Scientific Analysis/Calculation Administrative Change Notice

1. Document Number:	ANL-NBS-HS-000047	2. Revision:	01	3. ACN:	01
4. Title:	THC Sensitivity Study of Heterogeneous Permeability and Capillarity Effects				
5. No. of Pages Attached:	35

Figure 6.3-1. Schematic Representation of Seepage into an Emplacement Drift Situated in Unsaturated Fractured Rock

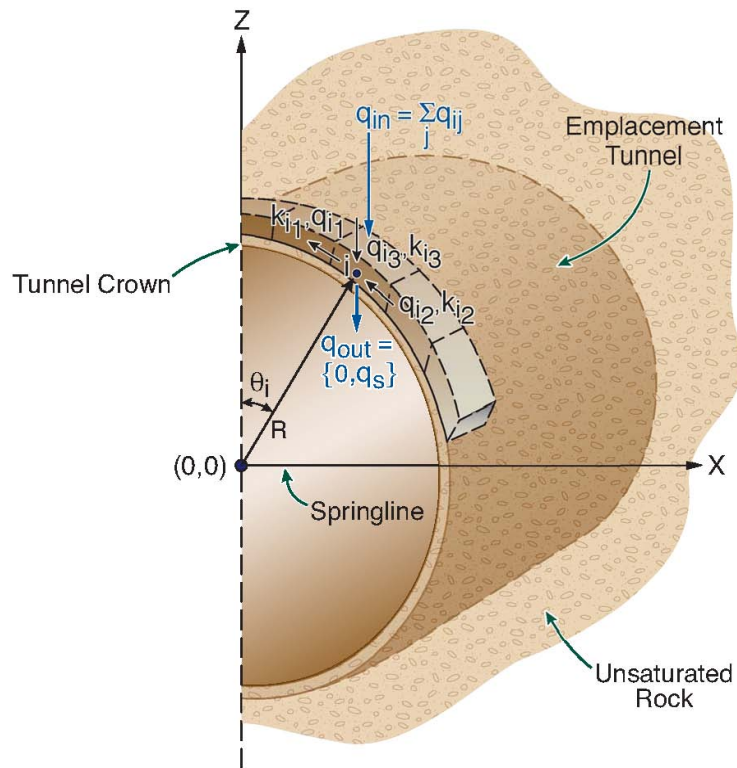
6-10	Figure 6.3-1: Replaced “Tunnel” with “Drift” in figure caption.				
6-14	Section 6.4.2, first paragraph: Replaced “tunnel” with “drift” in next-to-last sentence.				
6-18	Section 6.4.6, first paragraph: Replaced “tunnels” with “drifts” in last sentence.				
6-28	Section 6.4.11.2, first paragraph, second bulleted item: Replaced “tunnels” with “drifts”. Section 6.4.11.2, second paragraph: Replaced “tunnel” with “drift” in second sentence.				
6-29	First bulleted item: Replaced “tunnel” with “drift”.				
6-38	Section 6.5.1, first paragraph: Added the following after second sentence: “The numerical difficulty encountered by this simulation is specific to this simulation only, and has no impact on other simulations in this report. Recollect that different realizations of the same fracture permeability distribution are used in this report. For this particular simulation with Realization # 1 of the permeability distribution, the initial permeability of a few gridblocks and their spatial/temporal evolution were such that it resulted in a singular matrix in the chemical solver routine of the software TOUGHREACT. Thus non-convergence for this simulation was not because of any coding or data-entry error but because of a rare occurrence.”

Figure 6.6-3. Comparison of Seepage Fluxes from Ambient (Simulation ID: “base_r2_10x_lev_amb”), TH (Simulation ID “base_r2_10x_lev_th.”), and THC (Simulation ID: “base-r2_10x_lev_thc”) Simulations with IMF10 Infiltration Fluxes

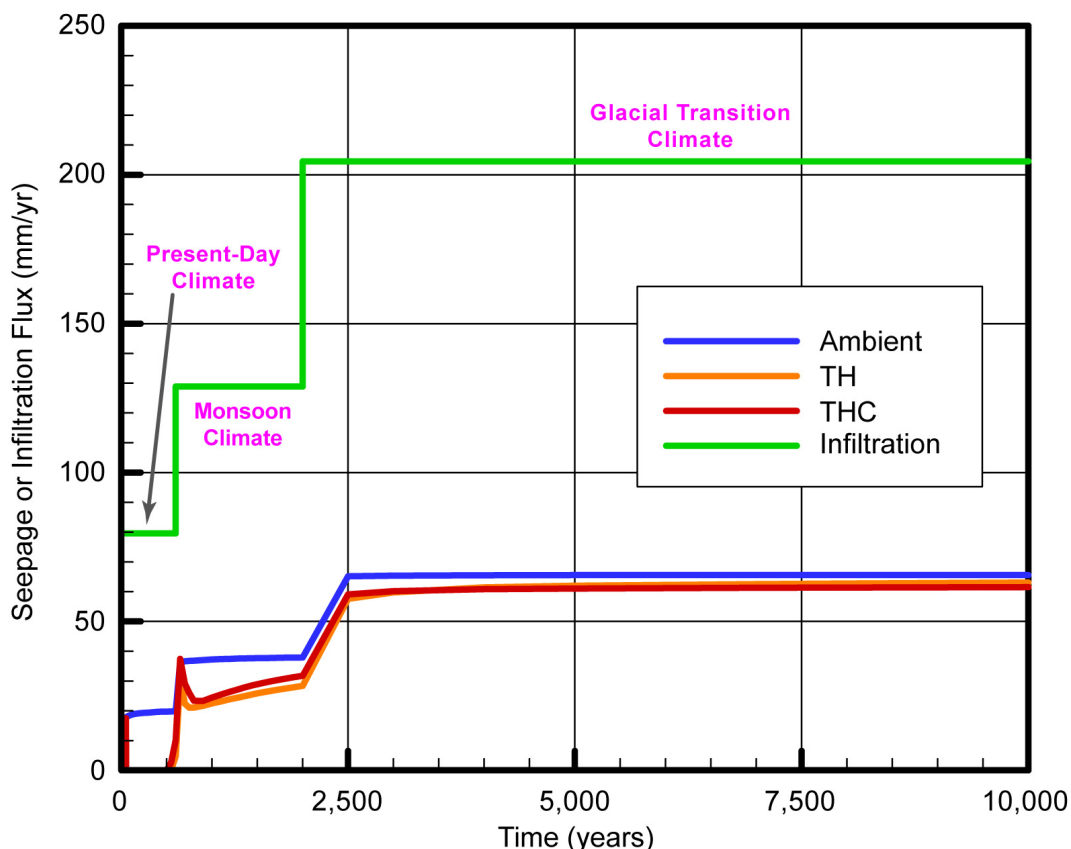
1. Document Number:	ANL-NBS-HS-000047	2. Revision:	01	3. ACN:	01
4. Title:	THC Sensitivity Study of Heterogeneous Permeability and Capillarity Effects				
6-48	<p>Figure 6.6-3: Replaced existing figure to remove climate-period demarcations; added “with IMF10 Infiltration Fluxes” at the end of figure caption; deleted sentence “The vertical violet lines are used to distinguish the different climatic periods and they do not represent any seepage data” in figure note.</p> <p>Section 6.6.2, first paragraph, lines 3 and 4: Added “effect” after “capillary-barrier”.</p> <p>Section 6.6.2, second paragraph, line 4: Changed “simulations shows” to “simulations show”.</p>				
6-49	Section 6.6.2, second bulleted item, last line: Added “computed” after “capillary-barrier effects”.				
6-53	Section 6.6.3, fourth paragraph, fifth line: Changed “though” to “through”.				
6-74	Figure 6.7-1: Replaced existing figure to remove climate-period demarcations; added “with IMF10 Infiltration Fluxes” at the end of figure caption; deleted sentence “The vertical violet lines are used to distinguish the different climatic periods and they do not represent any seepage data” in figure note.

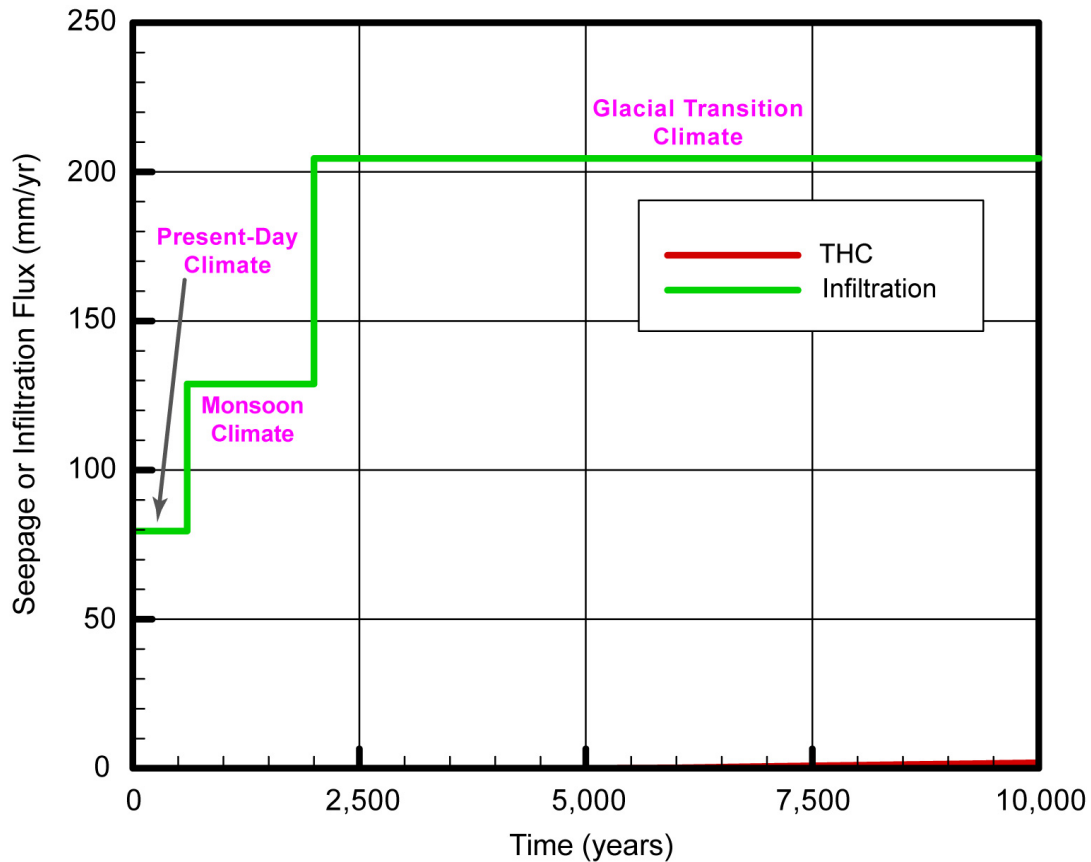
6-75	Figure 6.7-2: Replaced existing figure to remove climate-period demarcations; added “with IMF10 Infiltration Fluxes” at the end of figure caption; deleted sentence “The vertical violet lines are used to distinguish the different climatic periods and they do not represent any seepage data” in figure note.				
6-76	Figure 6.7-3: Replaced existing figure to remove climate-period demarcations; added “with IMF10 Infiltration Fluxes” at the end of figure caption; deleted sentence “The vertical violet lines are used to distinguish the different climatic periods and they do not represent any seepage data” in figure note.				
6-82	Figure 6.7-4: Replaced existing figure to remove climate-period demarcations; added “with IMF10 Infiltration Fluxes” at the end of figure caption; deleted sentence “The vertical violet lines are used to distinguish the different climatic periods and they do not represent any seepage data” in figure note.

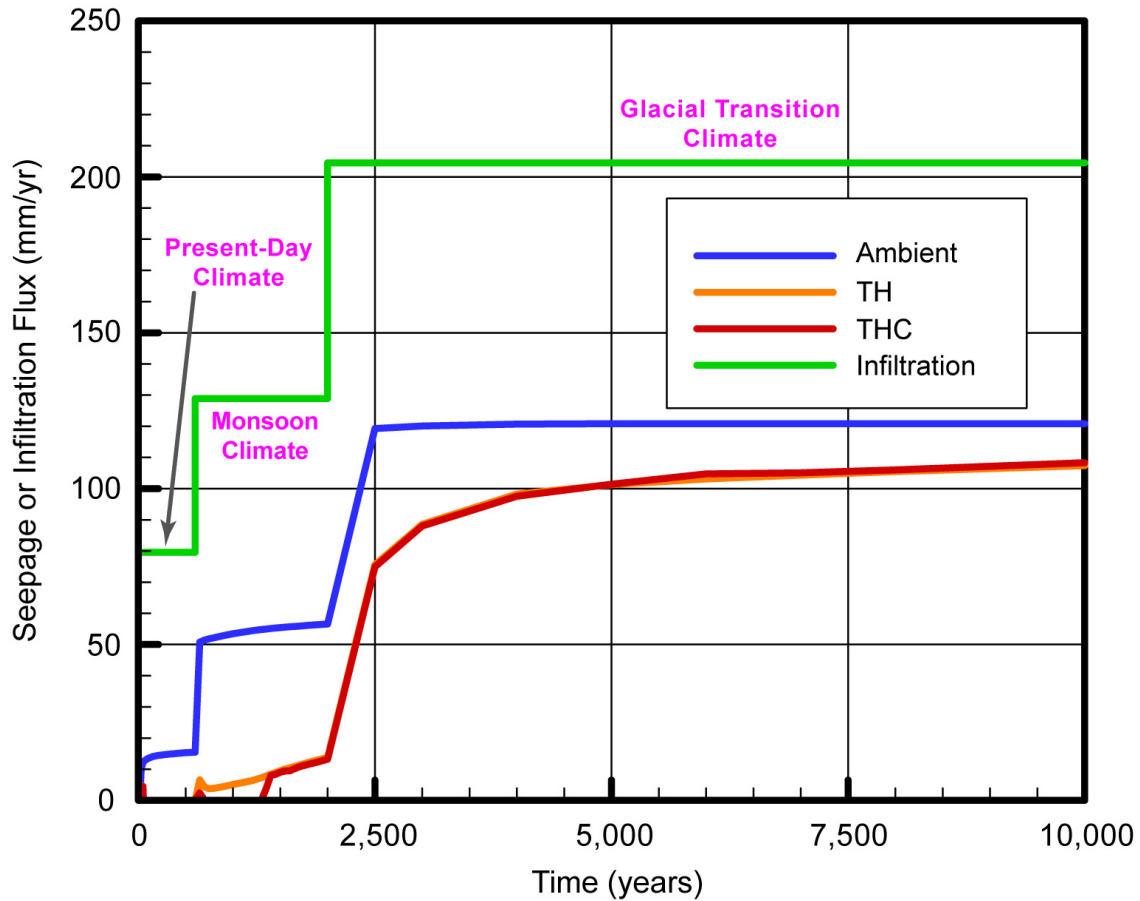
6-83	Figure 6.7-5: Replaced existing figure to remove climate-period demarcations; added “with IMF10 Infiltration Fluxes” at the end of figure caption; deleted sentence “The vertical violet lines are used to distinguish the different climatic periods and they do not represent any seepage data” in figure note.				
6-84	Figure 6.7-6: Replaced existing figure to remove climate-period demarcations; added “with IMF10 Infiltration Fluxes” at the end of figure caption; deleted sentence “The vertical violet lines are used to distinguish the different climatic periods and they do not represent any seepage data” in figure note.				
6-90	<p>Section 6.10, first paragraph, second to last sentence: Replaced existing sentence with “These simulations improve confidence with regard to seepage estimation under THC conditions”.</p> <p>Section 6.11, second paragraph, third sentence: Replaced existing sentence with “As mentioned in Section 1.1, the objective of these sensitivity studies is to improve confidence in the abstraction of drift seepage”.</p>
